**Chemung County Stormwater  
Construction Inspection  
Erosion and Sediment Control**

<b>Project Name</b> Hickory Grove Solar Farm	<b>Date</b> 8/3/2022
<b>Location</b> Hickory Grove Road Horseheads, NY	<b>Permit #</b> NYR11F809
<b>Weather Conditions</b> sunny	<b>Entry Time:</b> 1:03 pm
<b>On-Site Representative Present:</b> None	<b>Exit Time:</b> 1:27 pm

**PROJECT:** Hickory Solar Farm  
Town of Horseheads  
Municipal Inspection  
August 3, 2022

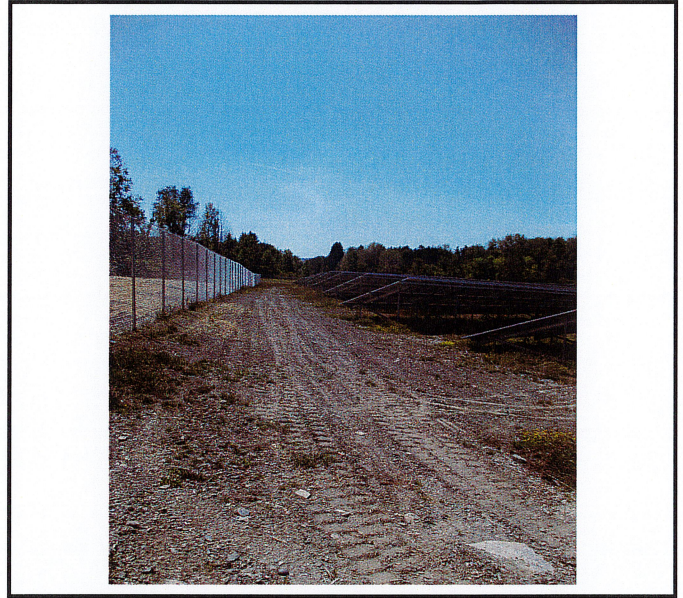
Parking/staging areas appear to be restored however are still compact.

Areas driven on during construction do not appear restored.

Areas restored have not been stabilized inside of the fence.

Contractor stockpile yard does not have the excessive mulch removed.
